Tight Clearance or Contact of TRD Pro LH Rear Shock Reservoir to Body

Some 2016 – 2018 model year 4Runner vehicles equipped with the TRD Pro suspension kit may exhibit a tight clearance or contact condition between the LH rear shock absorber remote reservoir and the inner wheelhouse body panel. A “knock” or “clunk” noise may be heard from the LH rear of the vehicle over bumps. Follow the Repair Procedure in this bulletin to address this condition.

This bulletin applies to ALL 2016 – 2018 model year 4Runner vehicles equipped with the TRD Pro suspension kit produced **BEFORE** the Production Change Effective VIN shown below.

Figure 1.

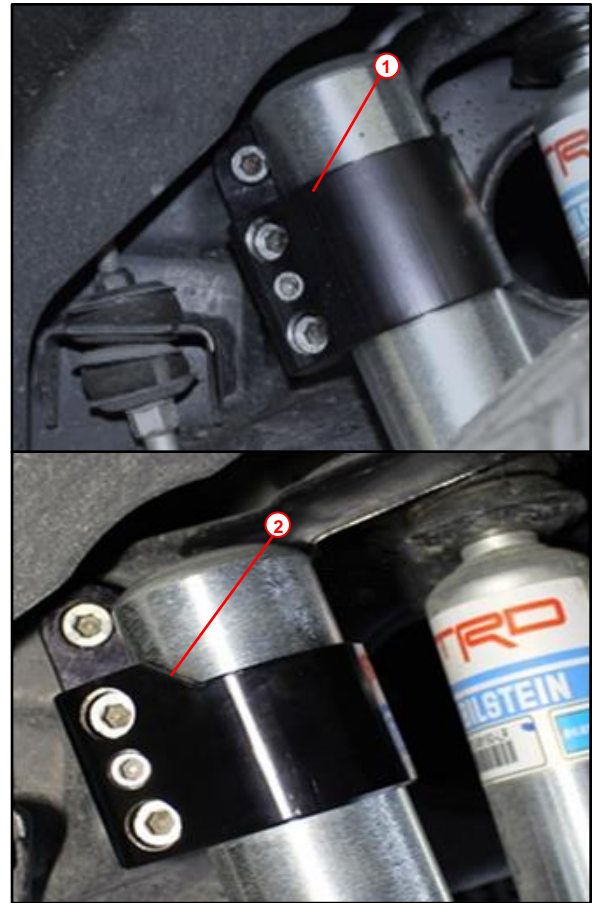
1. Check the shape of the reservoir bracket. Does the bracket have an angled step as shown?
 - **YES** — This bulletin does **NOT** apply. Continue diagnosis using the applicable Repair Manual.
 - **NO** — Continue to step 2.

Figure 2. Reservoir Clearance Measurement

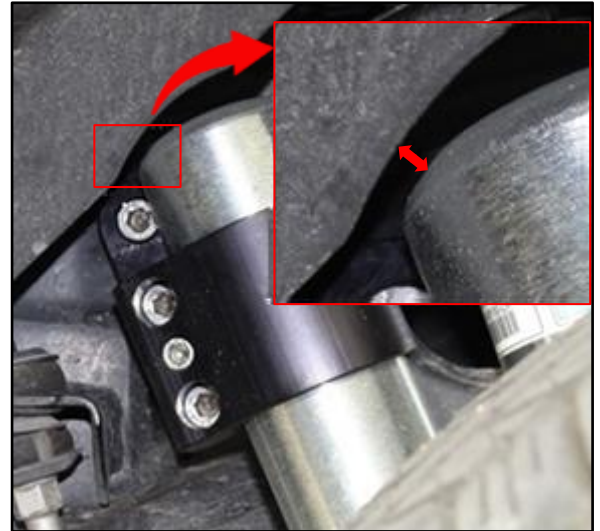
2. Measure the smallest distance between the LH rear shock reservoir end and the inner wheelhouse panel edge.

Is the clearance less than 5 mm?

- **YES** — Continue to step 3.
- **NO** — This bulletin does NOT apply. Continue diagnosis using the applicable Repair Manual.
